ADDENDUM NO. 3

May 3, 2022

YOST ELEMENTARY SCHOOL ADDITIONS AND RENOVATIONS
Chesterton, IN 46304

Addendum Three (AD.03) to the drawings and specifications prepared by Gibraltar Design for **New Newton Yost Elementary School** for Duneland School Corporation, Chesterton, Indiana.

1 A-701 UNIT "A" FIRST FLOOR EQUIPMENT PLAN

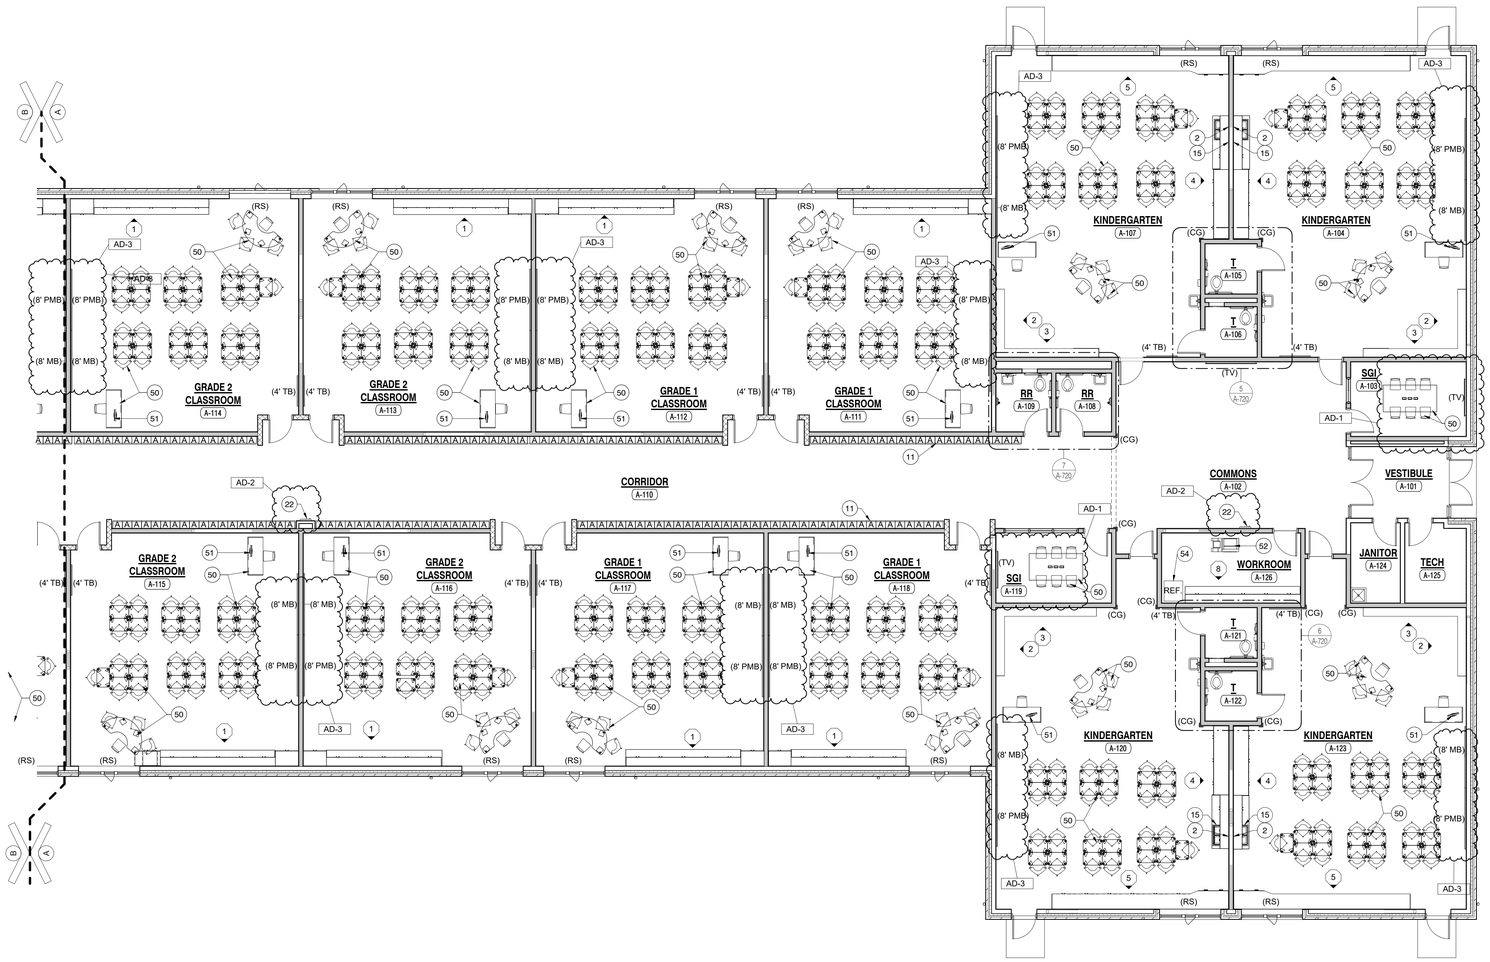
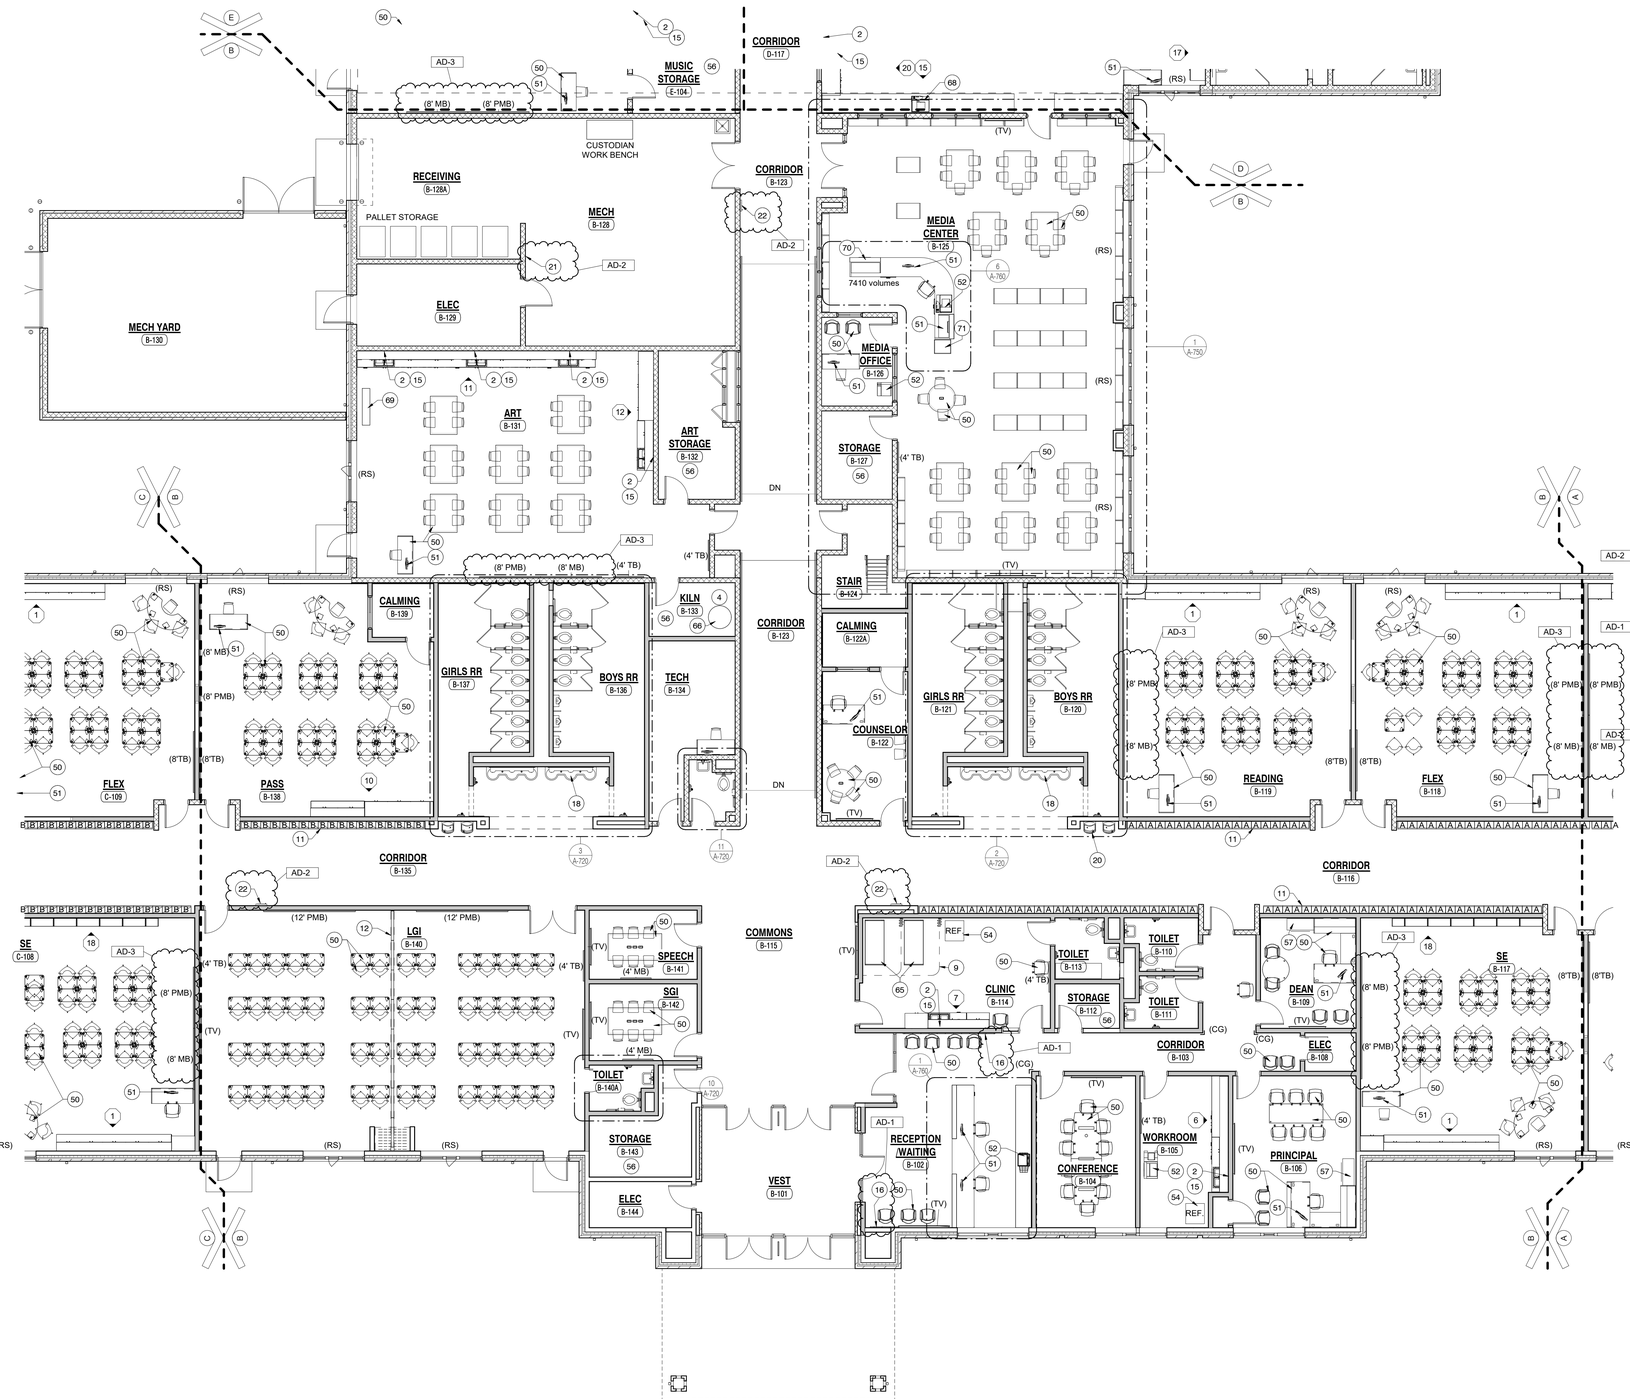
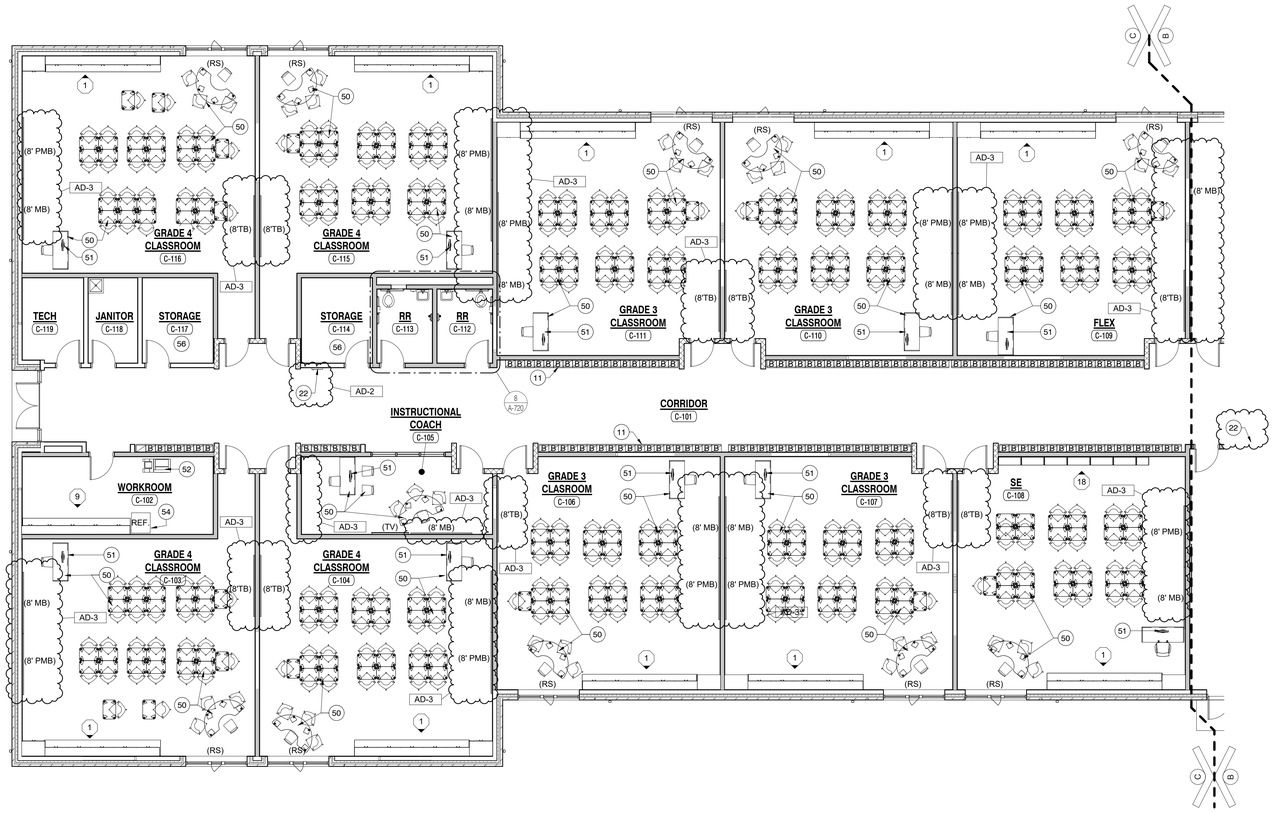
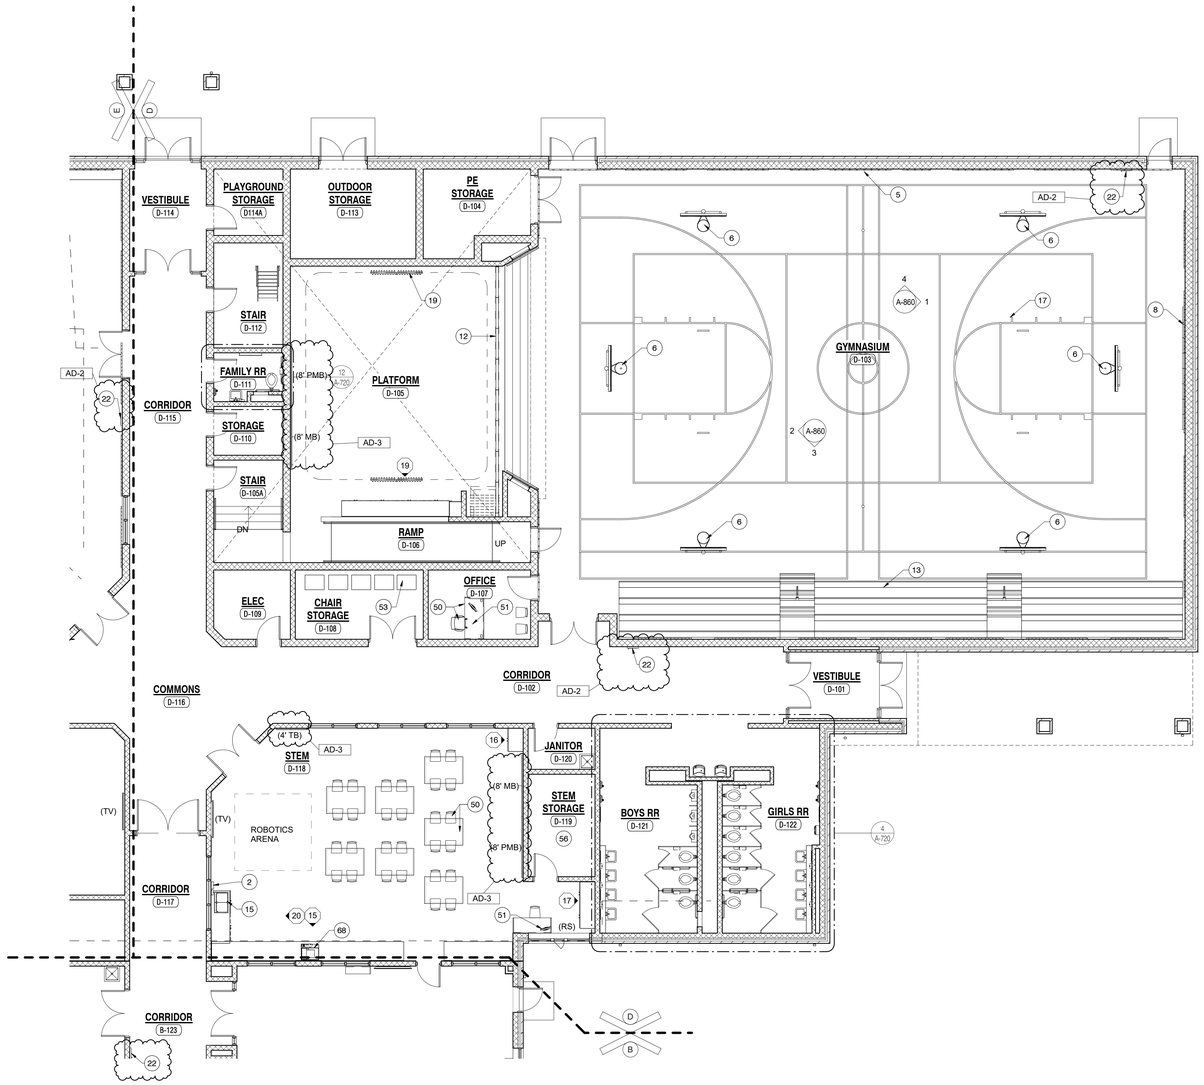
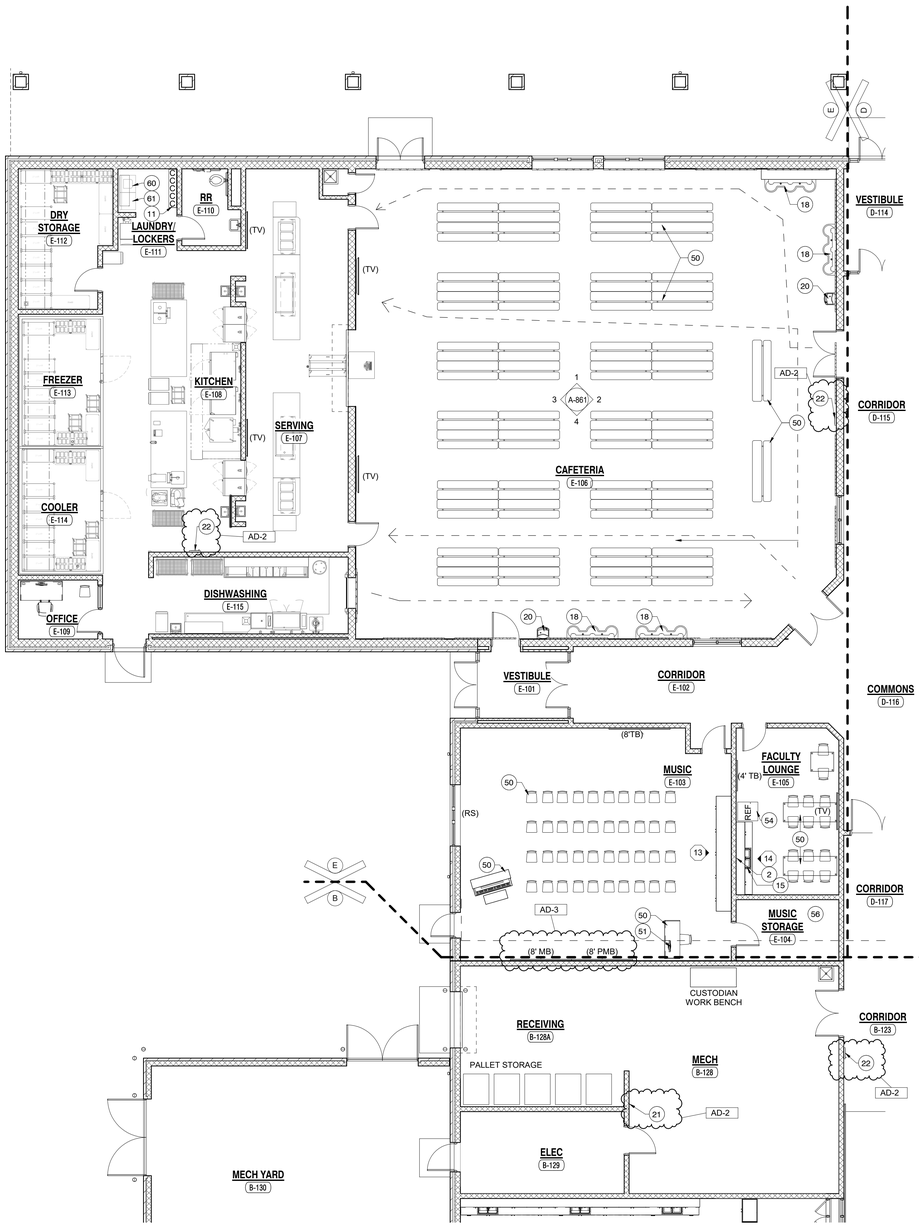
70. Sheet A-701, A-702, A-703, A-704, A-705

1 UNIT "A" FIRST FLOOR FINISH PLAN
A-801 1/8" = 1'-0"

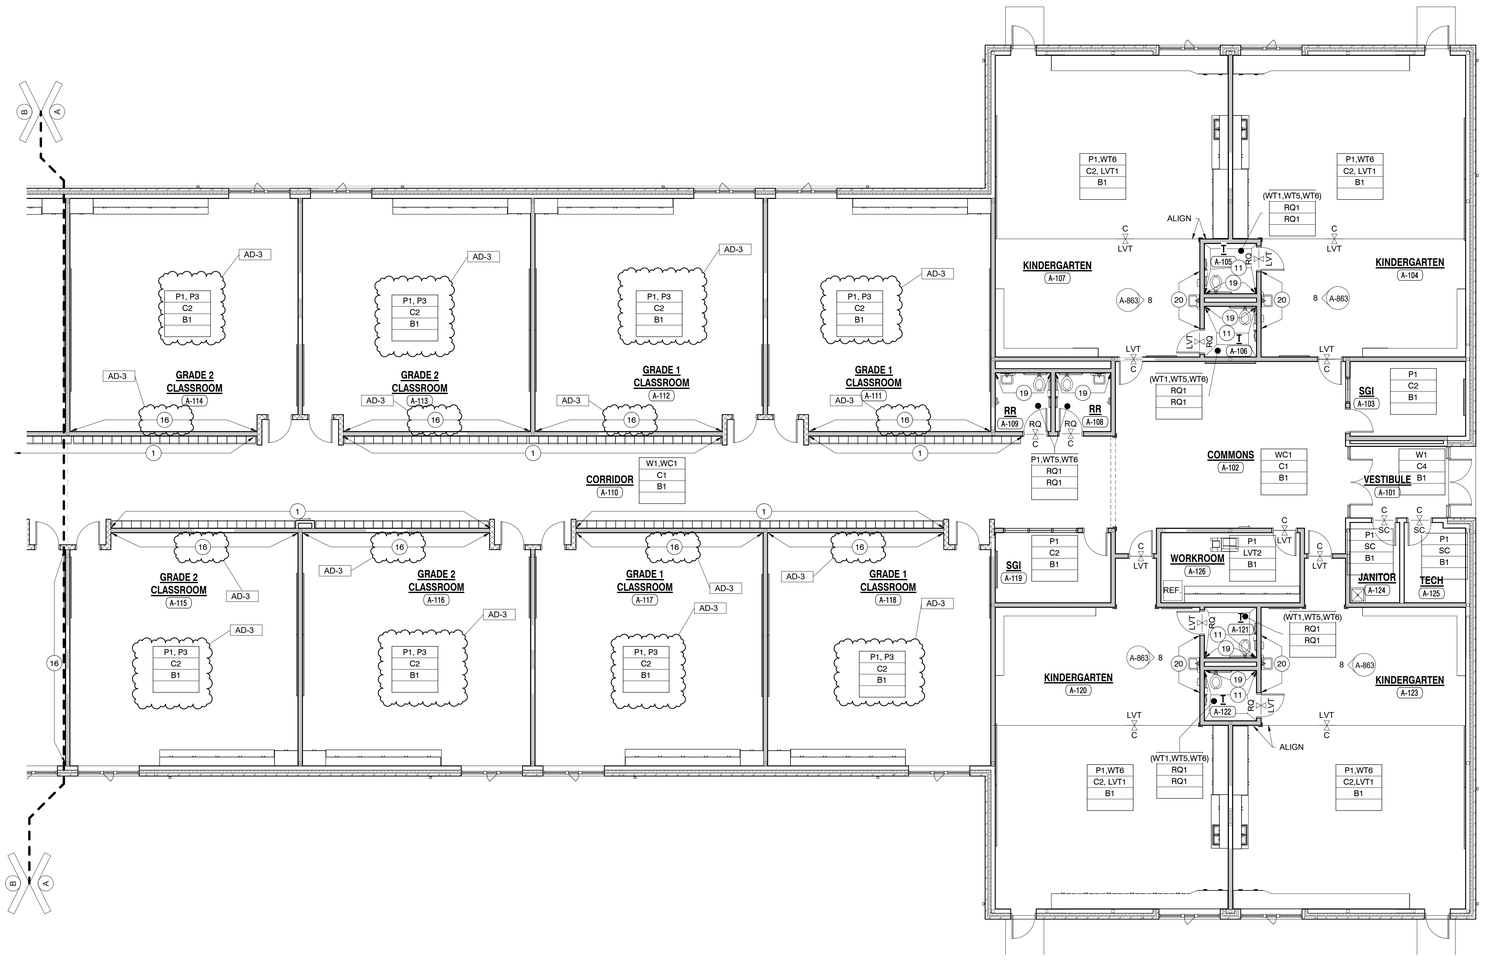
73. Sheet A-801

1 UNIT "B" FIRST FLOOR FINISH PLAN
A-802 1/8" = 1'-0"

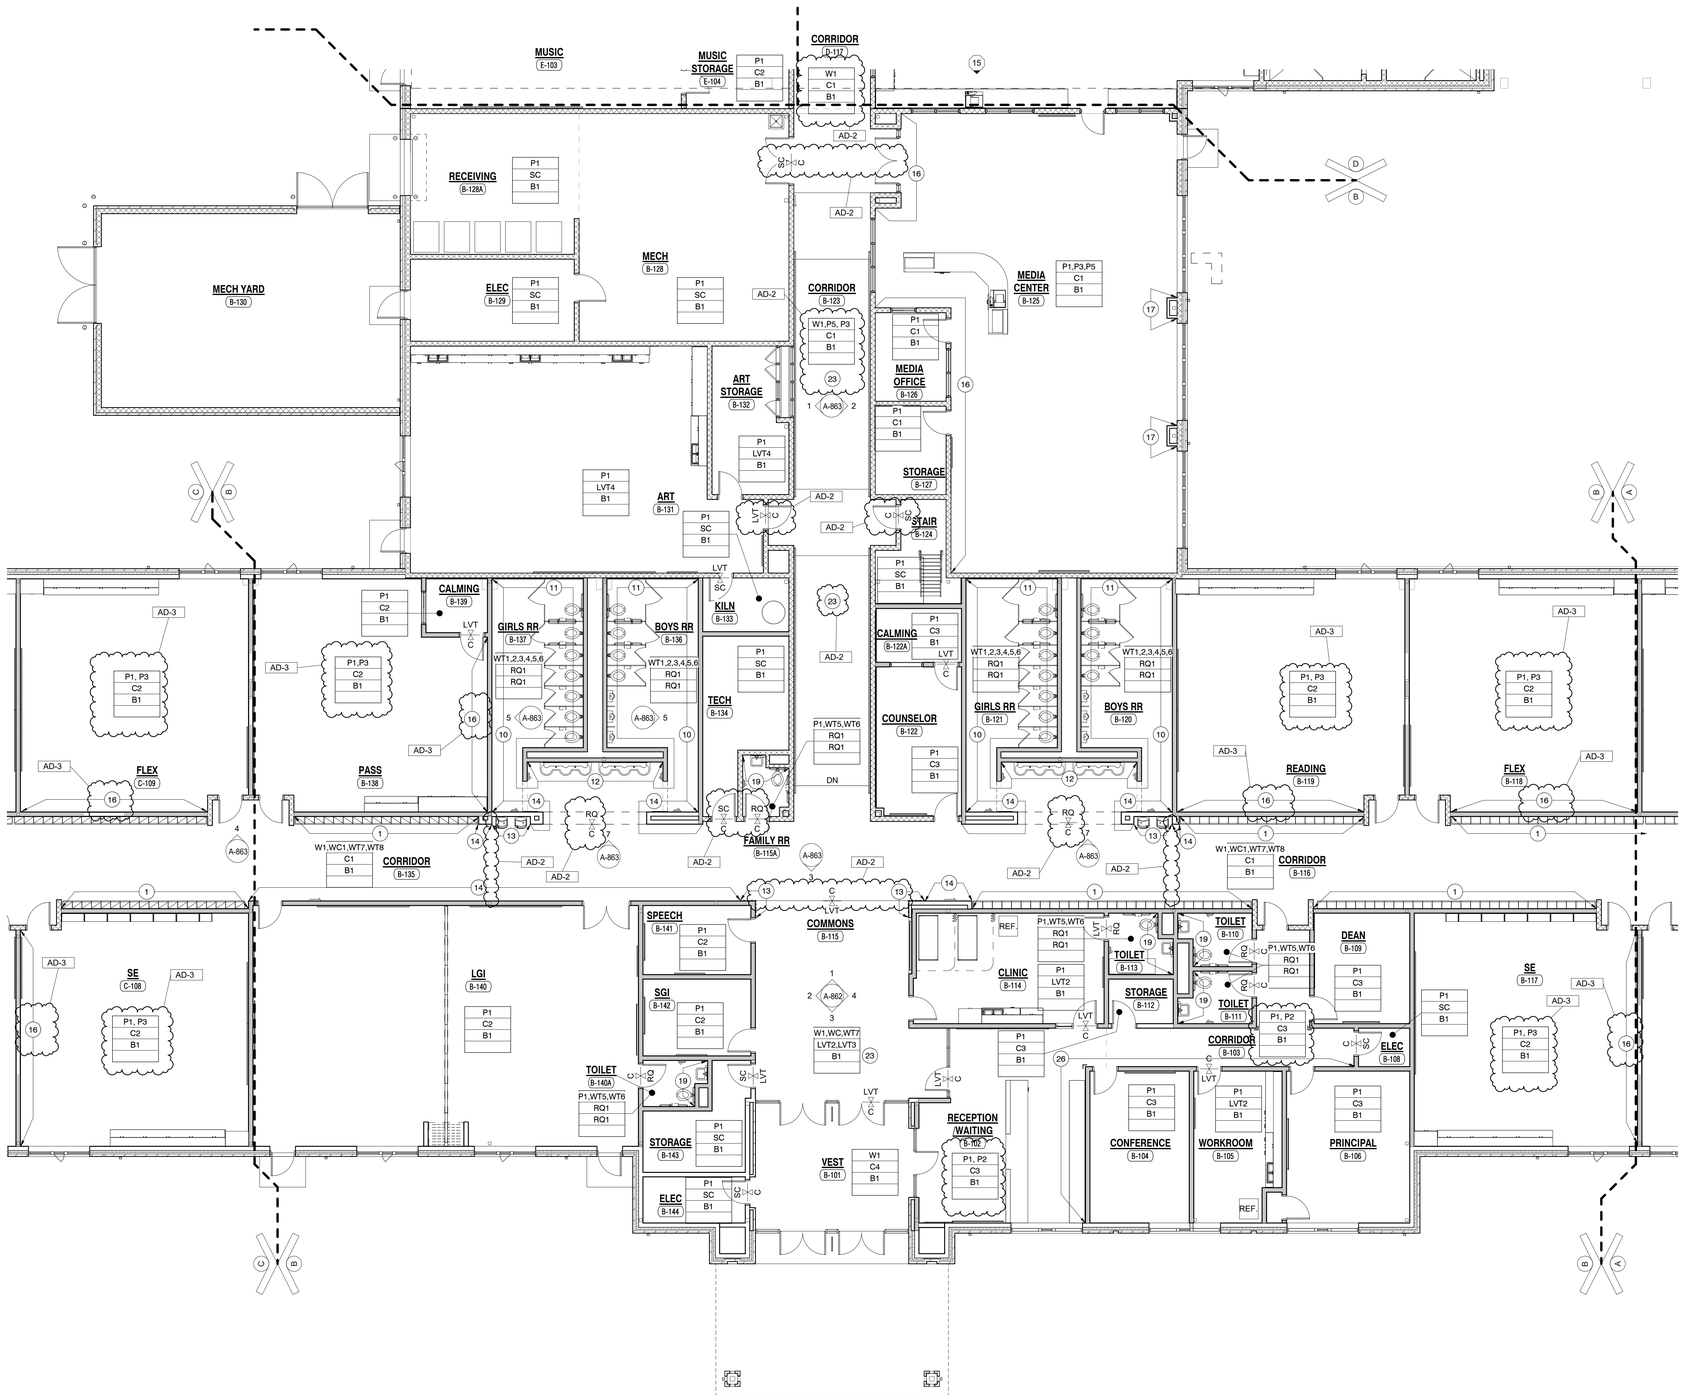
74. Sheet A-802
